# Intel® Ethernet Controller I210

## Specification Update

Revision 2.8  
332763-012

Figure 1-1. Explanation of Top Markings for A3 Stepping

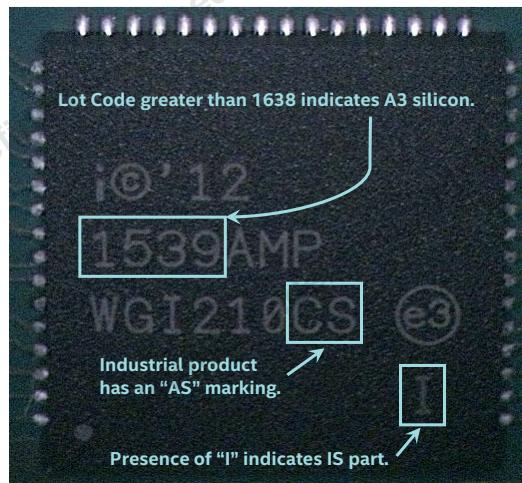
The A3 stepping only applies to the Fiber (IS/CS/CL) products. The A3 stepping can be identified by the Fab Lot Trace Code marking on the package or by the iNVM contents.

- Fab Lot Trace Codes starting with 1638 or greater are A3 devices.
- Bit 1 of INVM\_DATA[61] (0x12214) is 1b on A3 devices.
